This document is generated in response to the queries asked in the e-mail from Compliance Certification Services titled "Kyocera Wireless Corp, FCC ID: OVFKWC-KX9, Assessment NO.: AN05T4762, Notice#1". The queries asked in the e-mail received by Lin Lu on 10th of May 2005 are listed below followed by the responses for each of the questions.

Subject: Kyocera Wireless Corp, FCC ID: OVFKWC-KX9, Assessment NO.: AN05T4762, Notice#1

KX9C #X41Q CDMA-1900 ch600 Flat Phone Closed with 22.5mm Air Space

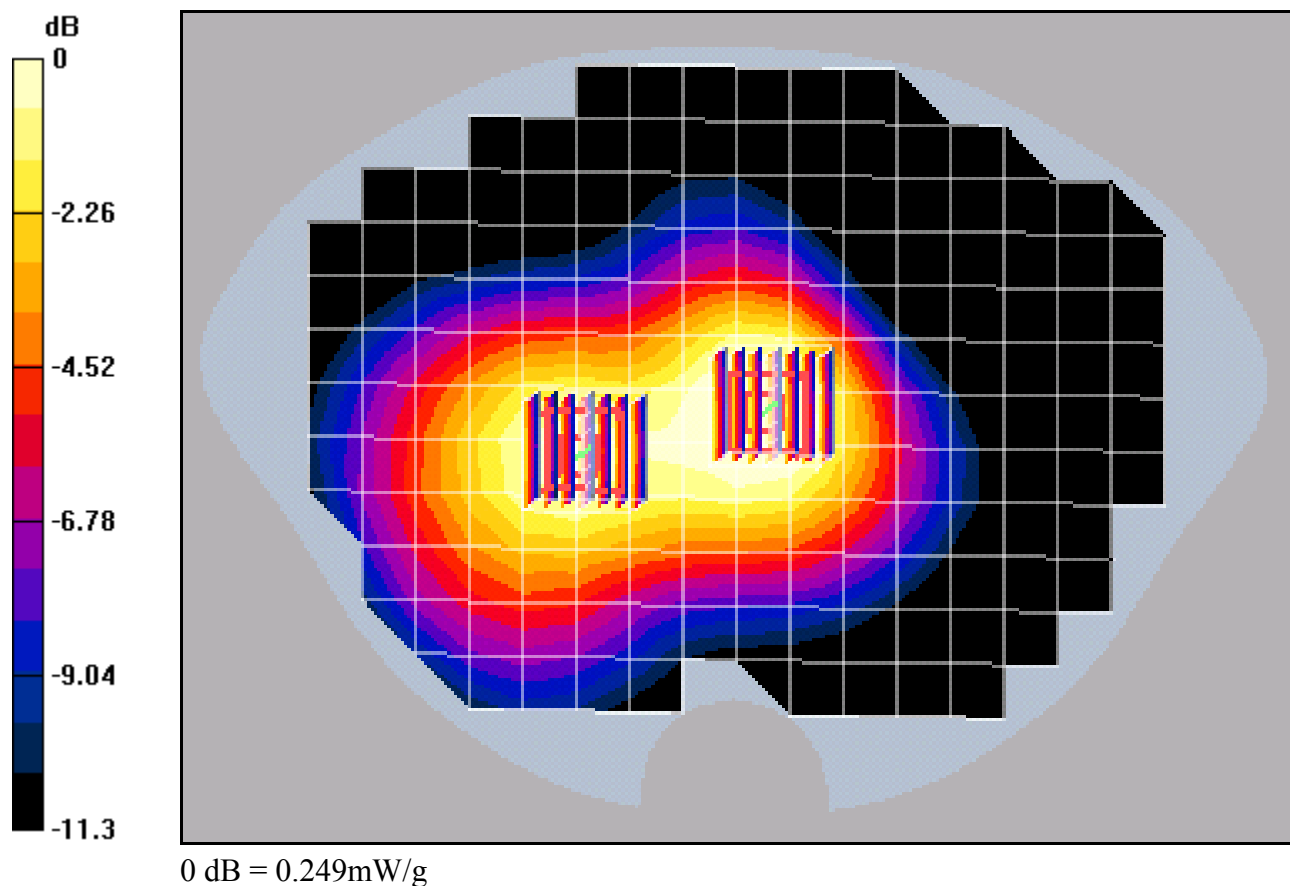
Question #3:Page 12 of Body worn SAR plots for 1900 CDMA @channel 600 air space, the SAR distribution plots indicate multiple hot spots, please provide secondary hot spot reading.

As per the request, we have measured the secondary hot spot for Page 12 of Body worn SAR plots for 1900 CDMA @ Channel 600 with 22.5 mm air space. The measurement table is listed below, followed by the SAR plot with the primary and secondary hot spots and the relevant validation.

CDMA 1900 BODY		Channel:			600	
		Frequency (MHz):			1880	
		Conducted Power (dBm):			23.36	
Configuration	Accessories	Test Position	Flip Position	Phone Position	SAR, 1g (W/kg)	
					Primary Peak	Secondary Peak
KX9C w/ standard battery	Air Gap – 22.5mm	Flat	Closed	Face Down	0.305	0.234
